**Silver Creek
Total Maximum Daily Load
For
Dissolved Zinc And Cadmium**

**Utah Department of Environmental Quality
Division of Water Quality**

(Approved by EPA August 4, 2004)

APPENDIX C – PUBLIC COMMENTS AND RESPONSIVENESS SUMMARY

Figure 5: Silver Creek Hydrology Map

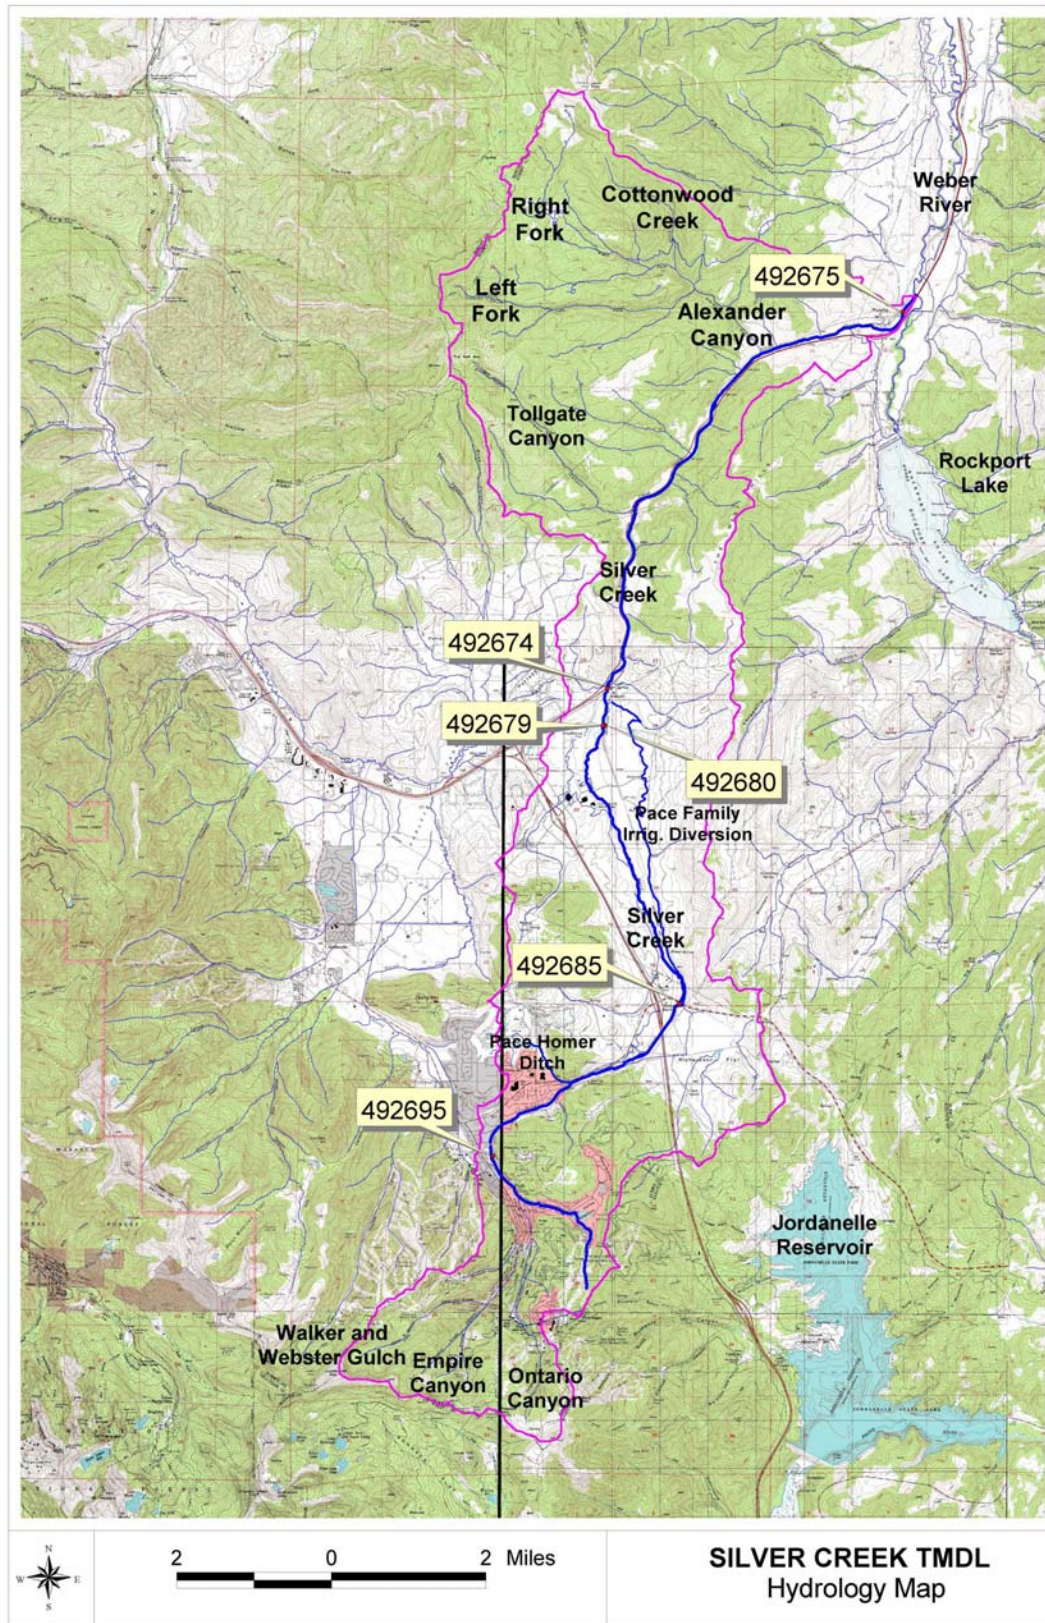
John, that is my review in a nutshell. The writing was clear. The figures where easy to read and interpret. Figure 5, the Silver Creek Hydrology Map, I thought should have been more legible. Maybe a smaller subset of maps that zero in on these areas would work better. The same comment applies to Figure 22- Silver Creek Contaminant Source Map. I would welcome a more detailed map from Prospector Square to Richardson Flat. Overall a nice Draft Report John.

Figure 13: Above Atkinson Bi-Monthly Zinc

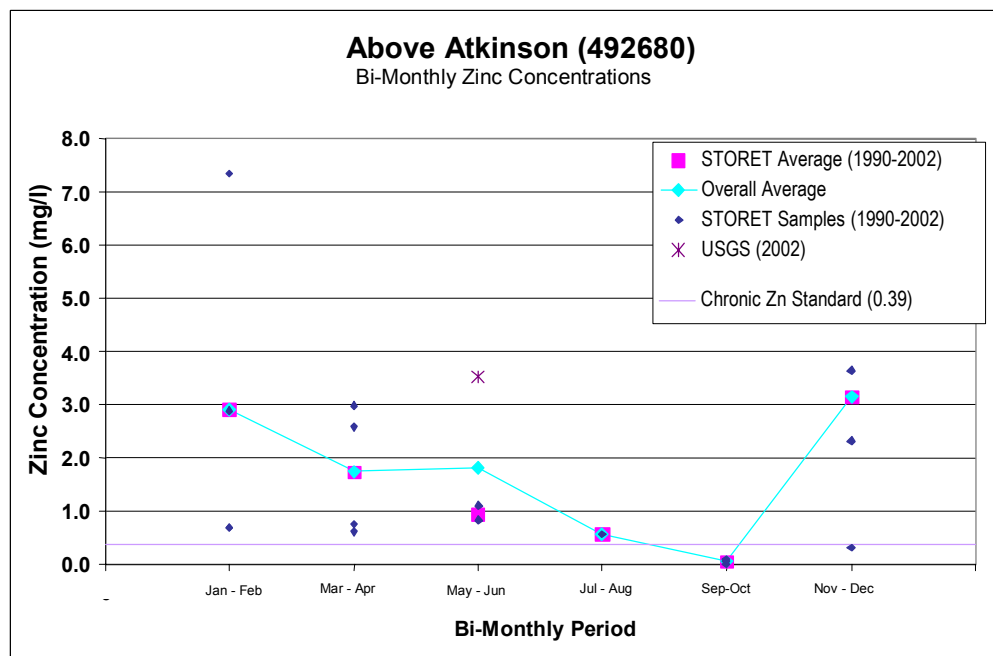
2. p. 22: Where our synoptic data are included the values are often high, as in figure 13. I would expect that because of the extreme dry conditions when we sampled.

Figure 22: Silver Creek Contaminant Source Map

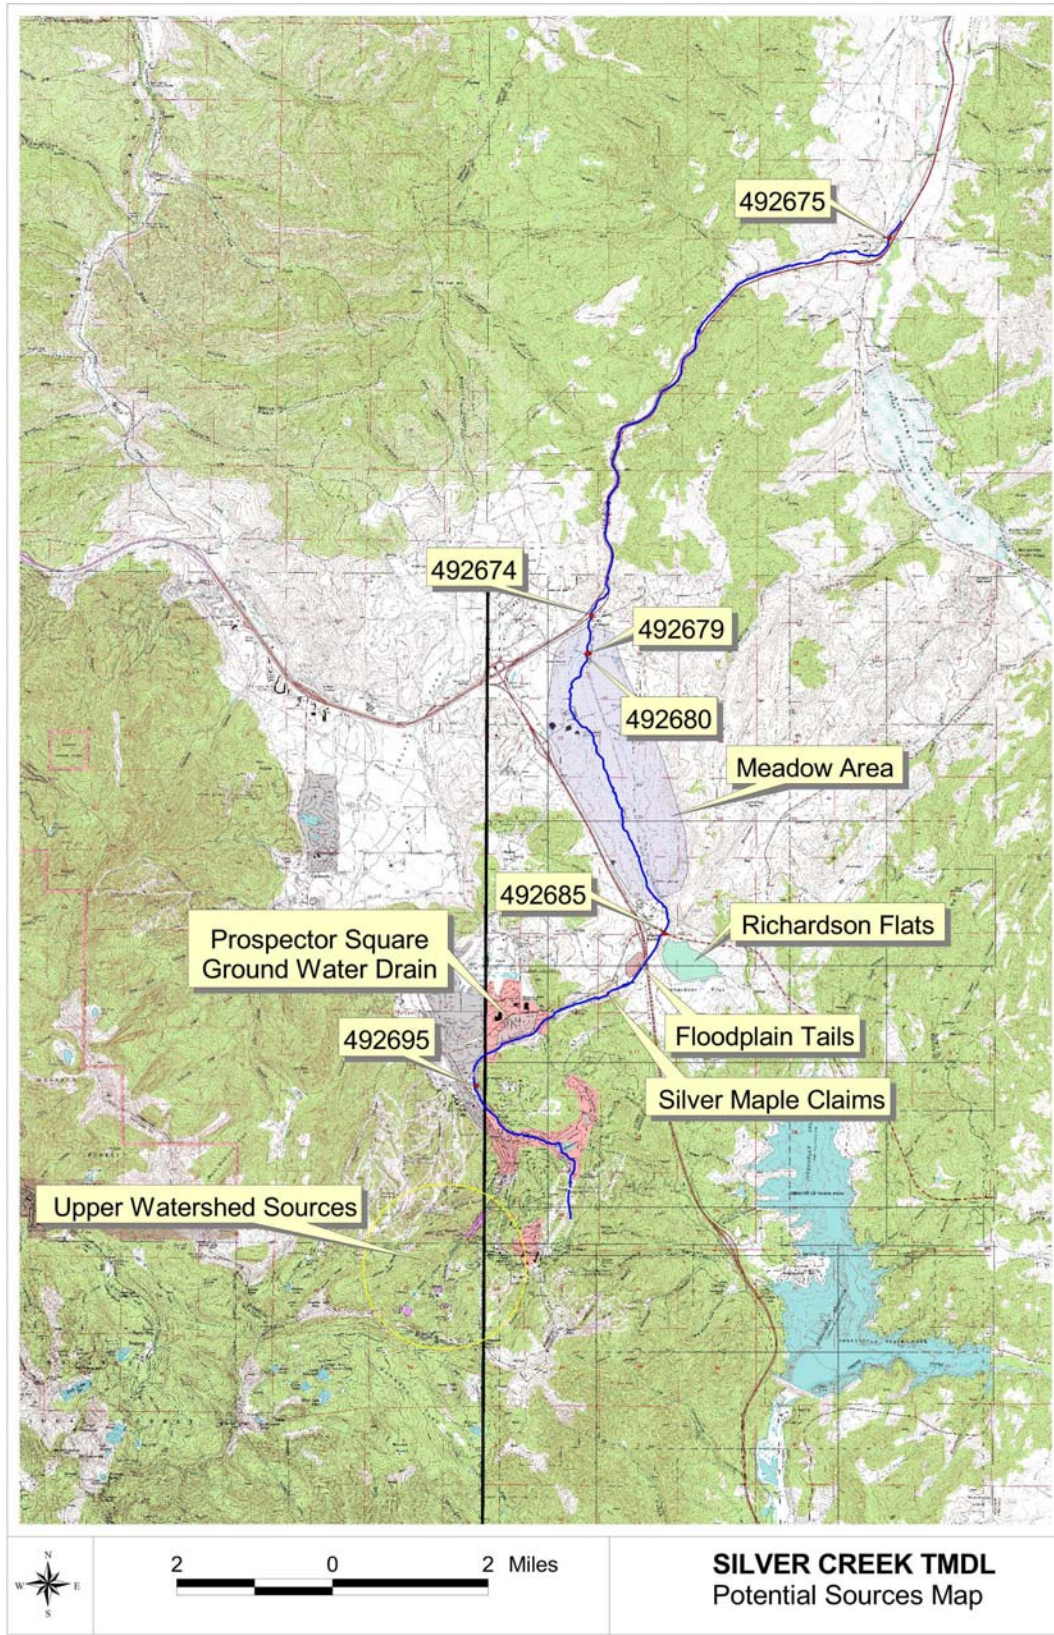
5. p. 34, figure 22: I don't thin you have the right location for the Prospector Square Ground Water Drain. It falls right on the stream.
6. p. 50, Prospector Square: the pipe is not upstream of Silver Maple but within Silver Maple, if the fence is right on the boundary.

Figure 1: Annual Patterns of Zinc Concentrations

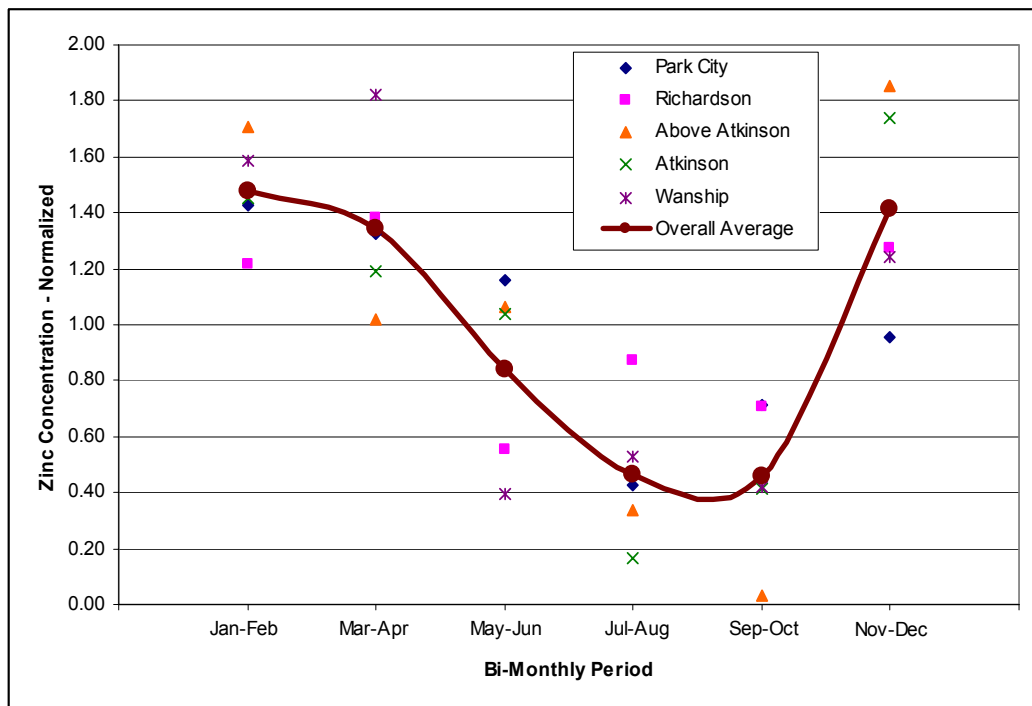
2. It appears that there is not sufficient data to track loads through the system and evaluate the relationships between concentration, flow and loads moving through the system. The use of average concentrations and flows to calculate loads and make assessments about loading in various sections of Silver Creek appears to be simplified and defining remedial objectives based on this analysis may be premature. As an example it is noted in the study that Zn concentrations are highest in the fall and winter months (see Appendix B, Figure 1) while the flows have not increased

Figure 2: Annual Flow Patterns

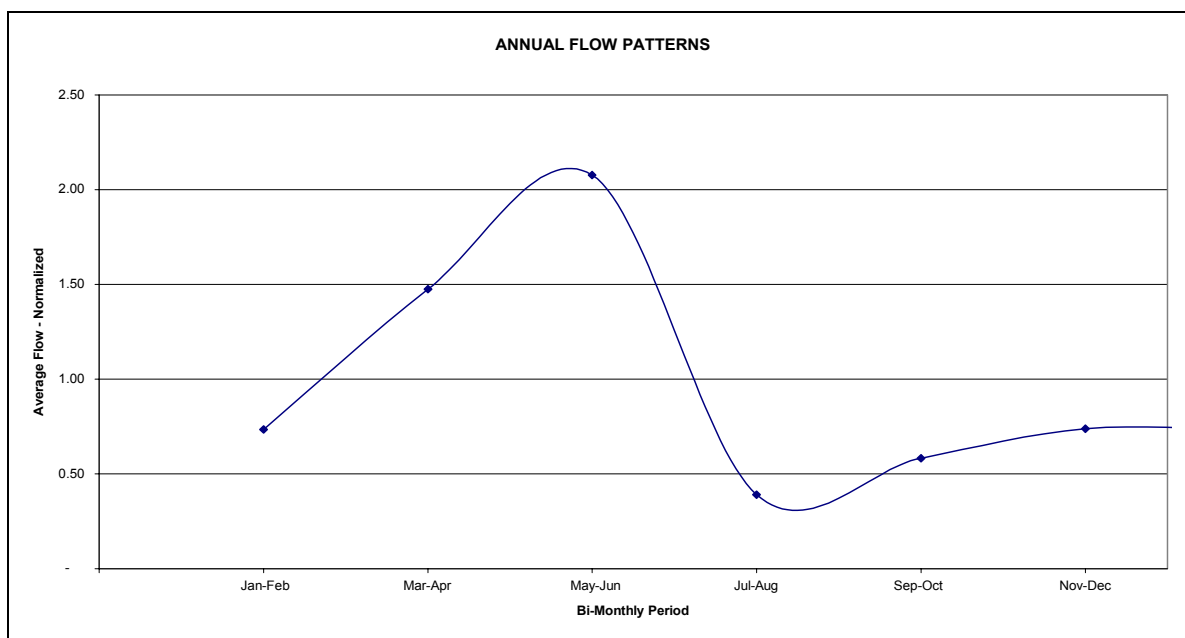
proportionally (see Appendix B, Figure 2). The reasons for this phenomenon have significant implications for the effectiveness of the various BMPs recommended. For instance, the concentration increases in the fall and winter could be that the system is dominated by shallow groundwater recharge impacted by the nearby tailings. Conversely the increases could be related to greater infiltration and stream recharge as evapo-transpiration drops off. The successful remediation associated with these two cases would involve very different approaches.

Figure 6: Bimonthly Hardness

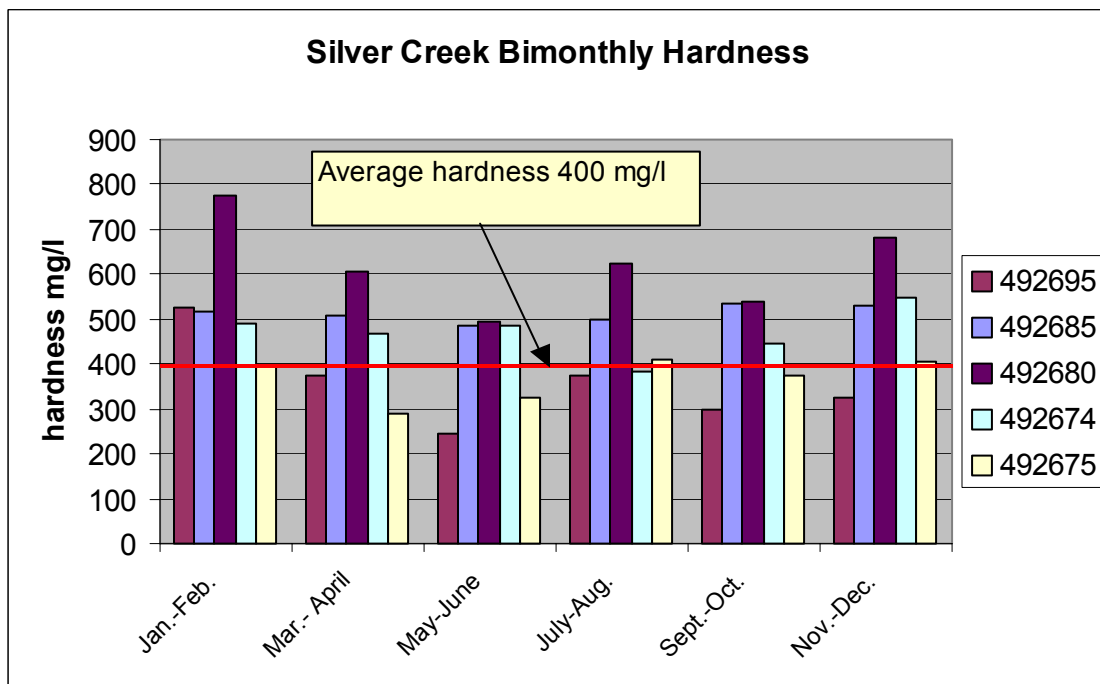
In Section 8.1, the document indicates that that average hardness at Park City and Wanship is lower than 400 mg/L for the bimonthly periods March-April and May-June. Figure 6 in Appendix B shows that hardness is also substantially lower for the Park City site during the bimonthly periods Sept-Oct and Nov-Dec. Therefore, it would be appropriate to apply lower water quality standards for zinc and cadmium here as well.
